INDEPENDENT REVIEW NGONGOTAHĀ FLOOD EVENT 29 APRIL 2018

REPORT DATE;
DECEMBER 2018

As a response to the flood and the impact it had on Ngongotahā and the wider district, RLC, in conjunction with the Bay of Plenty Regional Council (BOPRC), commissioned an independent Panel to investigate the events of 29 April 2018 and to make recommendations intended to reduce the impact of severe flood events in the future.

Figure 25: Flood Level Comparison – Ngongotahā Road to Lake

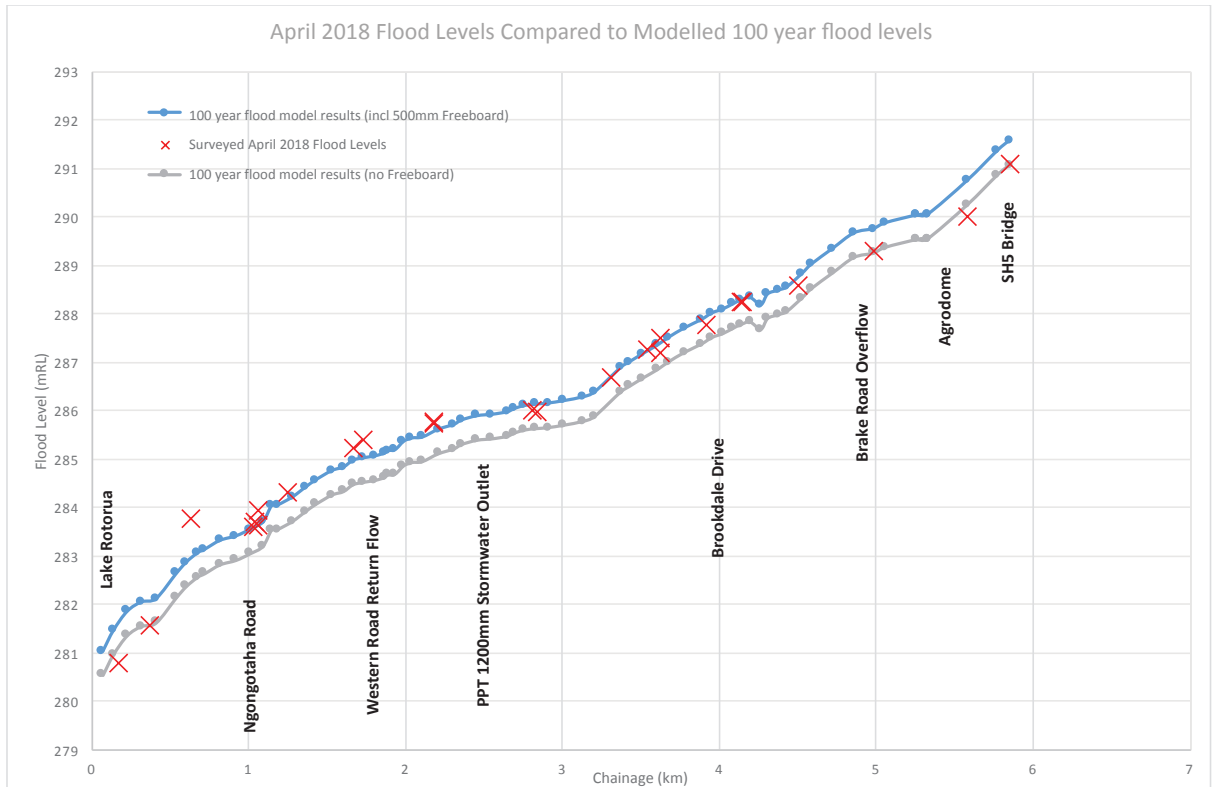
There are three distinct conclusions drawn from inspection of this flood level comparison with modelled flood levels. Firstly, the levels from SH5 through the Agrodome down to where the overflow occurred very closely match the modelled flood levels (without freeboard). Although this reach is considered to be the most thickly vegetated (See Figure 26) of the stream downstream of SH5 the roughness characteristics used in the hydraulic model ($n = 0.1$ to 0.14) provide an accurate reflection of these channel conditions. There are certainly opportunities for reducing levels through this reach with the removal of significant channel blockages, but this would likely result in increased flood flows in the downstream reach, so a comprehensive solution that resolved downstream capacity issues would need to be addressed first.

Figure 37: Outline plan of overland flow path and locations where calculations were undertaken (Source – MTEC Drawing 175781-R-P-D002 N.B. colours added by Review Panel for clarity)

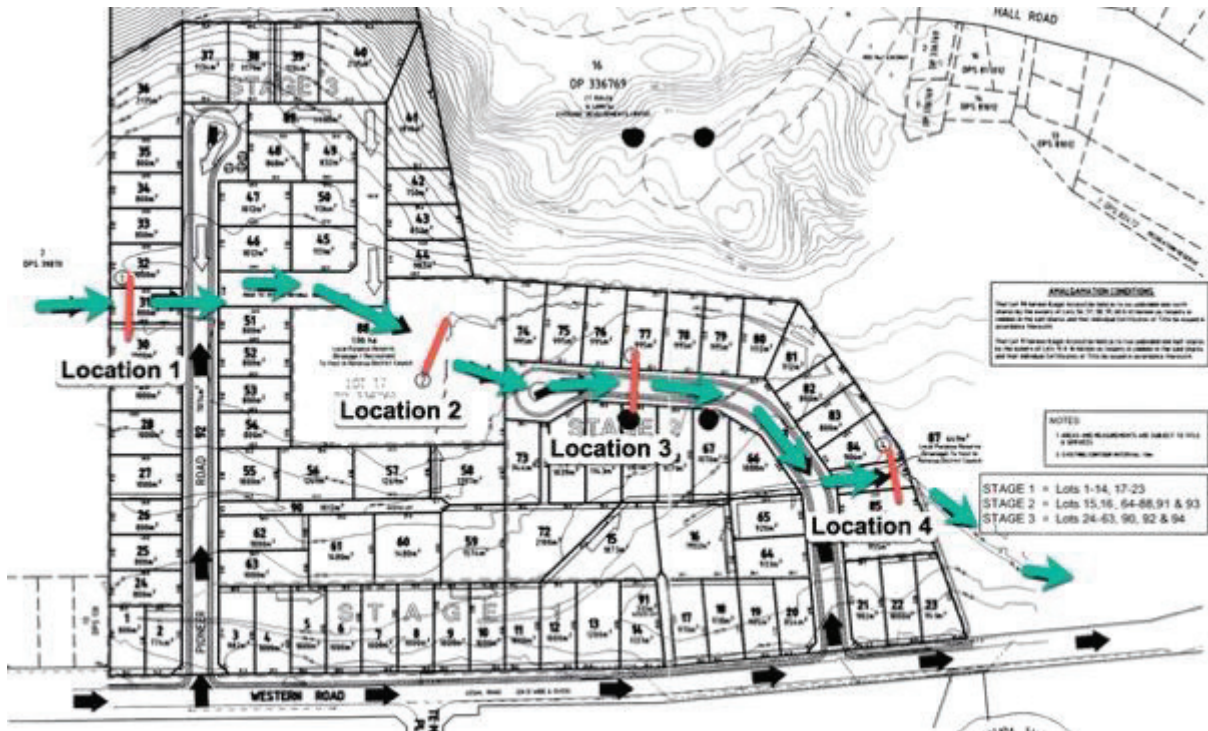
The hydraulic design of the overland flow path was provided to RLC in correspondence from MTEC dated 12 January 2006. The calculations presented were undertaken at four discrete cross sections (See Figure 37) within the subdivision and were effectively a calculation of the hydraulics at that particular point without specific consideration of hydraulic connectivity between each location or of backwater effects between the eastern boundary and Western Road. In general terms this methodology is very approximate, and its use could result in an overland flow path that would not perform to the required design standard.

Figure 38: MTEC design cross section and calculations at location 1

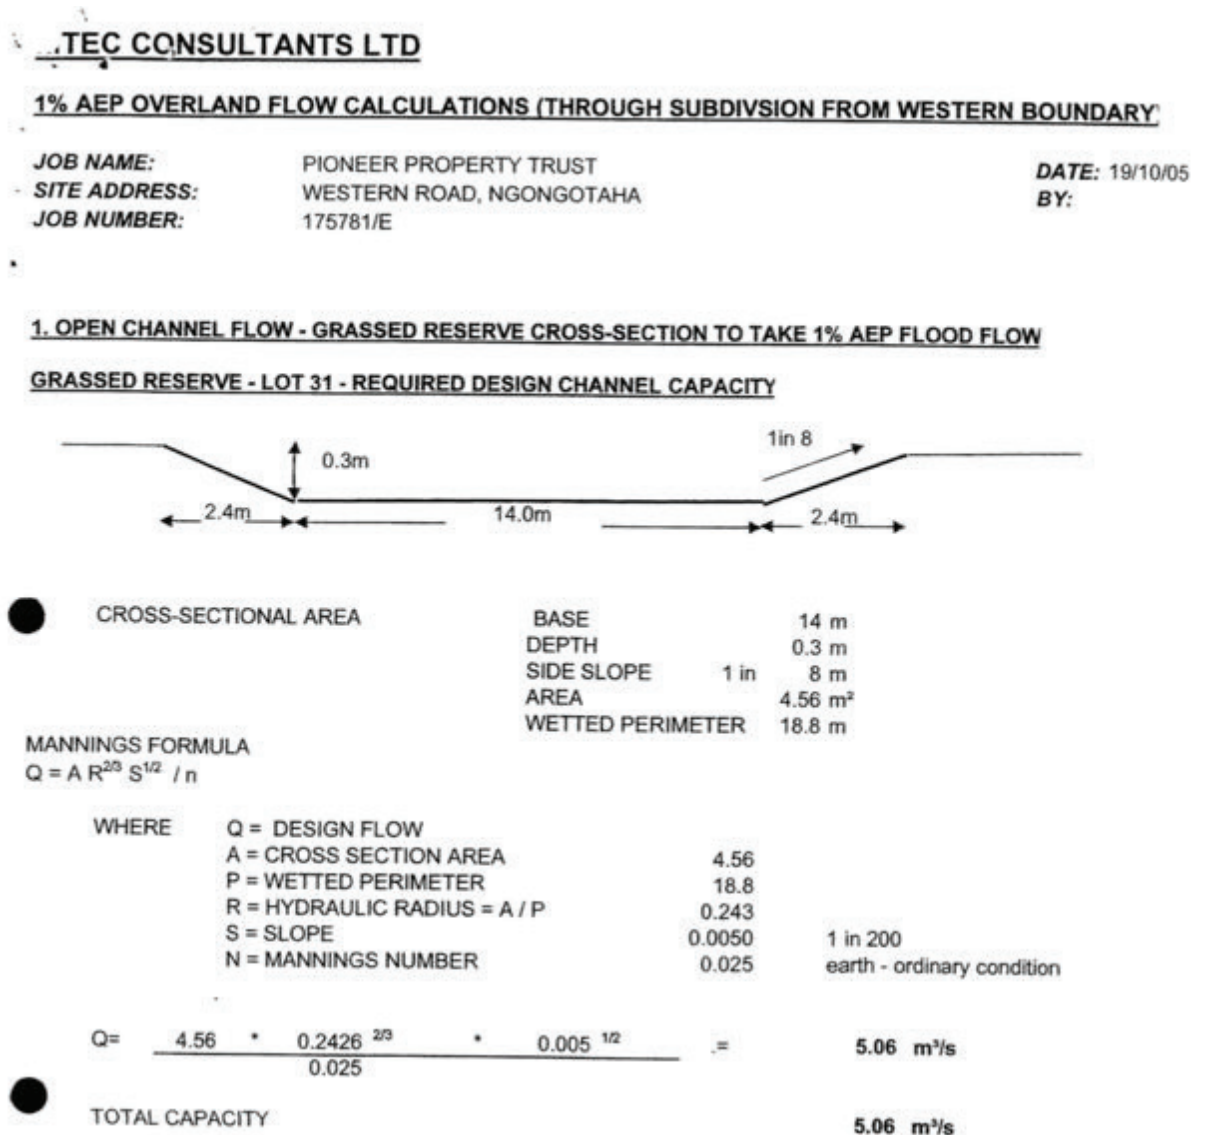
This is the most upstream location of the overland flow path near the western boundary of the PPTS. The slope used in the calculation of 1 in 200 appears appropriate based on the post development earthworks contours, but the Manning's n of 0.025 would appear to be too low, especially for shallow flow conditions. Inspection of Figure 4-5 in Henderson (1966), with appropriate conversion of length units, would suggest a more realistic Manning's n in the range 0.04 – 0.05. Increasing the Manning's n to 0.04 would result in an additional 100 mm of flow depth. There is also a lack of freeboard added to allow for uncertainty, particularly in recognition of the very crude method of analysis. Using a Manning's n of 0.04 with the width and side slope dimensions provided for by the MTEC channel along with the provision of 300 mm freeboard would have seen a channel 0.7 m deep with a bank full (no freeboard) capacity of approximately 15 m³/s.

Figure 39: MTEC design cross section and calculations at location 2

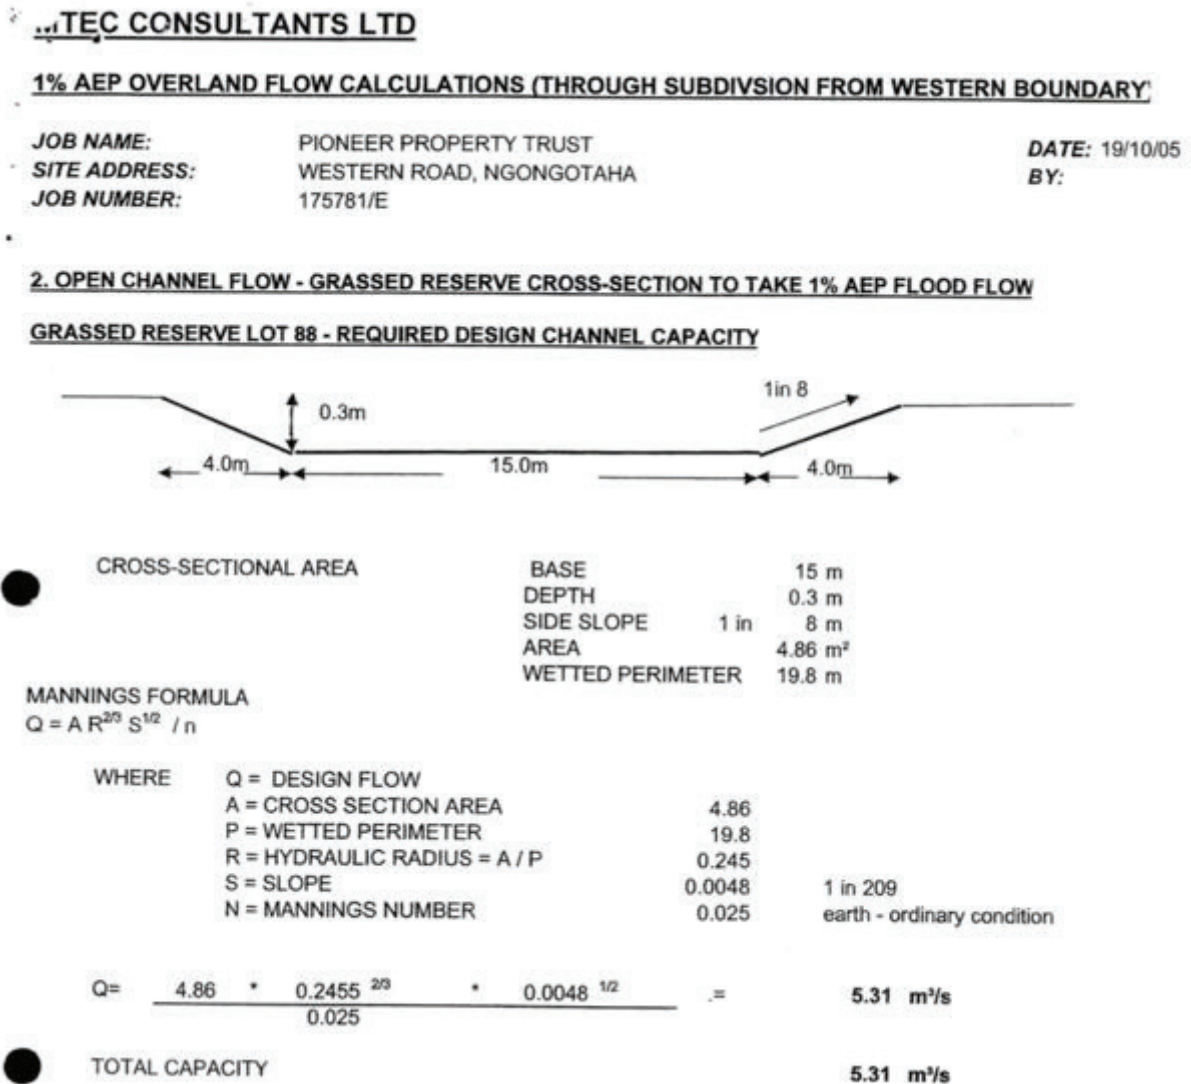
The calculations at this next downstream location also indicated an over optimistic Manning’s n of 0.025, no freeboard and no consideration of upstream and downstream connectivity. There also appears to be some inconsistency between the dimensions on the sketch and those in the calculations particularly with regard to the side slopes of the channel (1 in 8) and the horizontal distance of 4 m with a depth of 0.3 m which would provide a distance of 2.4 m. This discrepancy is not material compared to the optimistic Manning’s n and the lack of freeboard.

Figure 40: MTEC design cross section at location 3

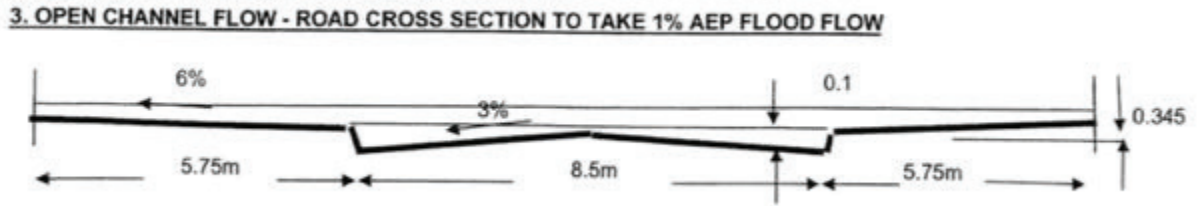
At this location the calculations have been split between the portion of flow on the road and that on the berms, with a maximum depth on the road (at the bottom of kerb) of 0.5 m reducing to 0.345 m at the road crown with a section average velocity of approximately 1.1 m/s. This provides a depth times velocity range of 0.38 – 0.55 m²/s which exceeds the typically expected range from a vehicle stability and safety perspective. The limits presented in section 7.2.4.2 of the Australian Rainfall & Run-Off Guidelines suggest limits of 0.3 to 0.45 m²/s for small and large passenger cars respectively. Large 4WD drive vehicles have a limit of 0.6 m²/s. As designed, using the road and berms to pass this amount of flow would present safety issues for people trying to egress the site in a vehicle during a flood.

Figure 43: Approximate extent of overland flow path Western Road – Pioneer Road – Mohi Crescent for 72 m³/s flood event in Ngongotahā Stream (Red crosses denote dwellings inundated during April 29 event and subsequently issued with insanitary notices)

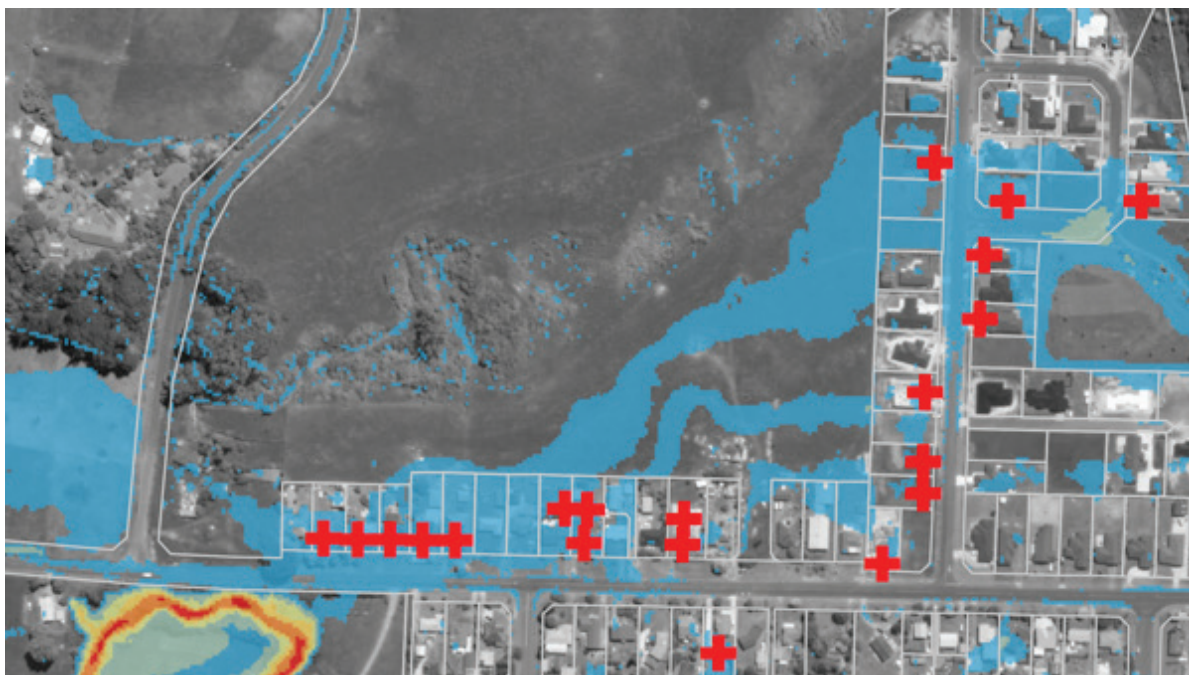
Inspection of Figure 43 shows the issues at the upstream end of the overland flow path with flow dispersed along the boundary at three discrete locations and being some 100 m wide where it enters the 20 m wide overland flow path at the eastern edge of the PPTS. The overland flow is clearly not contained or conveyed within the 20 m wide channel as it passed through the dwellings on Pioneer Road & Mohi Crescent before entering the RLC reserve at the western end of Oakland Place. A total of nine dwellings within the PPTS were inundated and issued with insanitary notices in this area.

Figure 44: Approximate extent of overland flow path Oakland Place - Western Road (Elliot Park) for 72 m³/s flood event in Ngongotahā Stream (Red crosses denote dwellings inundated during April 29 event and subsequently issued with insanitary notices).

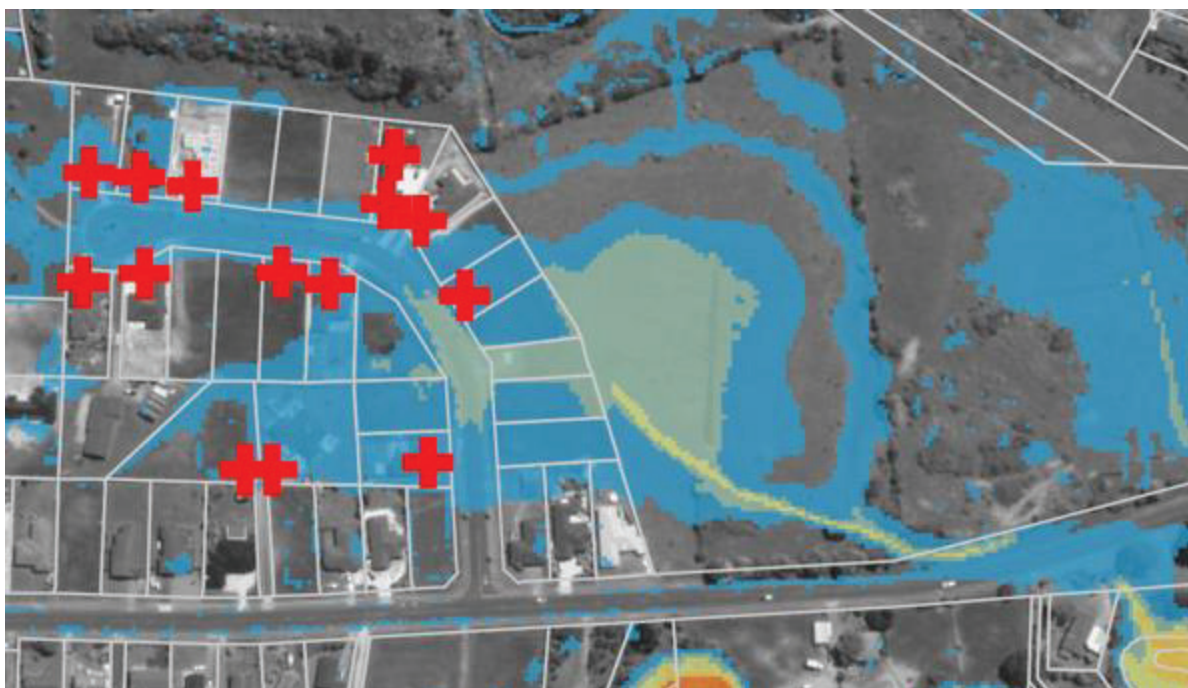
Moving downstream to the next reach of the overland flow path shown in Figure 44 the flows do appear to be reasonably confined within the road, but the flood mapping in this area is most likely to be underrepresenting the actual flooding that occurred as evidenced by the 14 insanitary notices issued in this area. Attention in particular is drawn to the nature of the flood extent downstream of Oakland Place with the notable ponding area on the adjacent property but with the confined outlet flow on the north of Western Road. It is within this area where most of the hydraulic grade between Western Road and Oakland Place will have been generated.

Figure 45: Plan view of 1200 mm stormwater outlet line from PPTS development

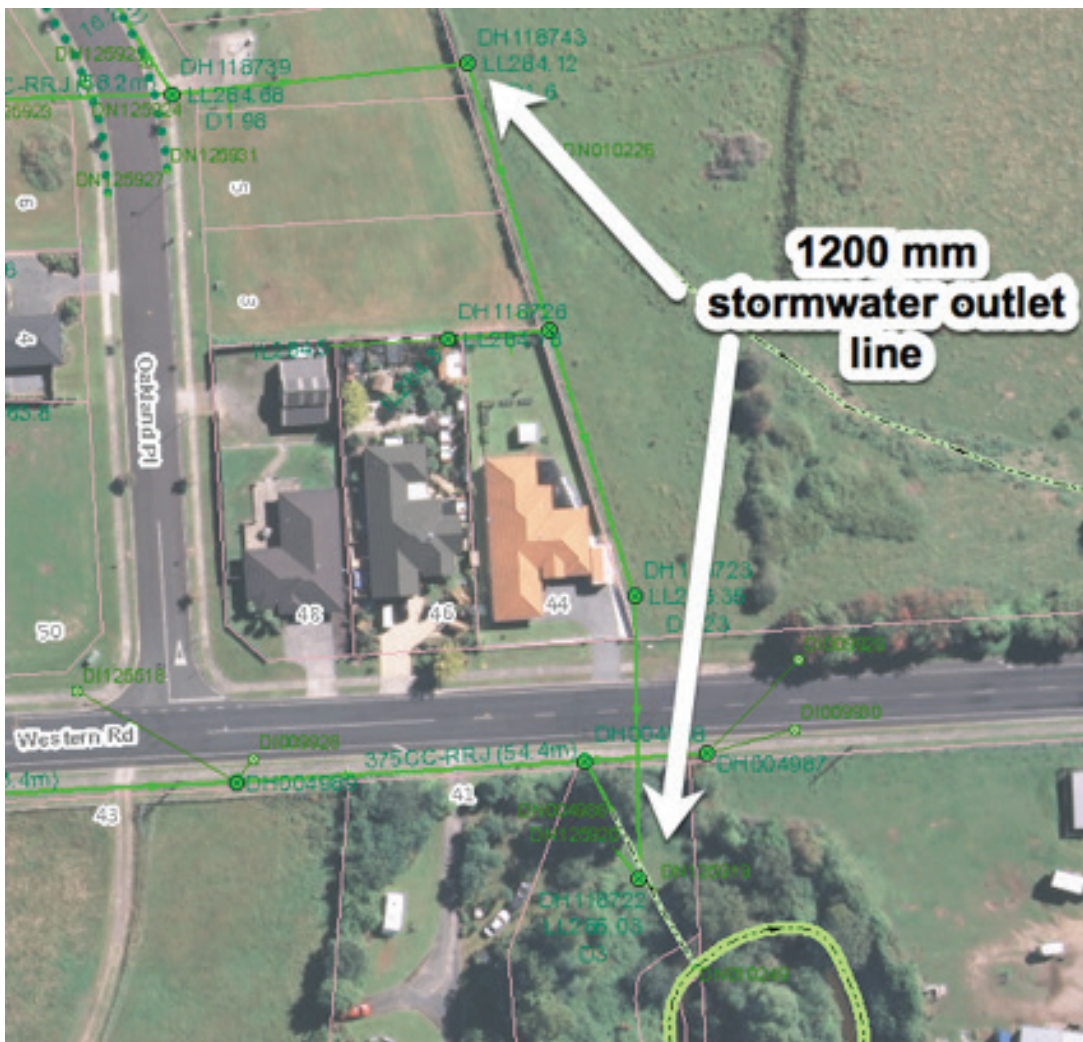
- The expected tailwater levels in the Ngongotahā Stream at the outlet of the 1200 mm diameter pipe servicing the development;
The subsequent hydraulic design of the 1200 mm diameter pipe from the outlet in Ngongotahā Stream to the PPTS boundary.

Figure 48: Structural works for consideration around Agrodome/Brake Road/Brookdale Drive

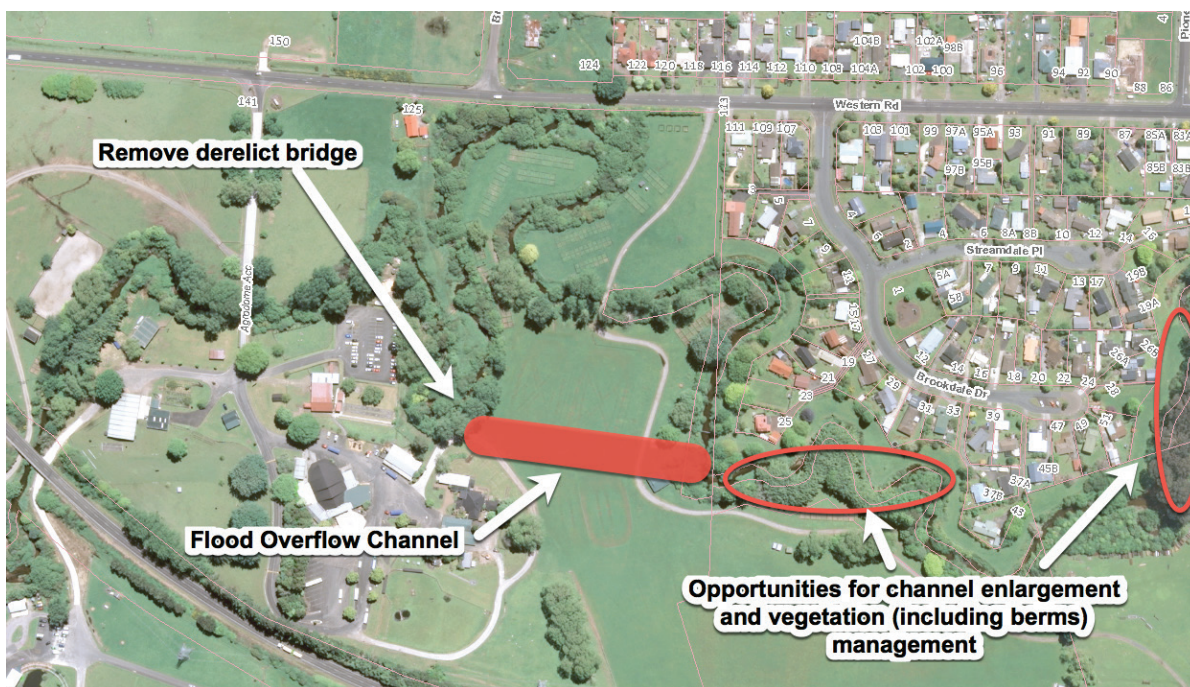
The benefits of a flood overflow channel within the Agrodome land to divert a portion of flow away from the Brake Road overflow area would appear to be an option worthy of consideration. This of course would have to be in conjunction with consideration of the upgrades required to the downstream channel and stopbanks to mitigate the effects of the increased flows within the main channel. Figure 48 below provides an indicative arrangement for further consideration.
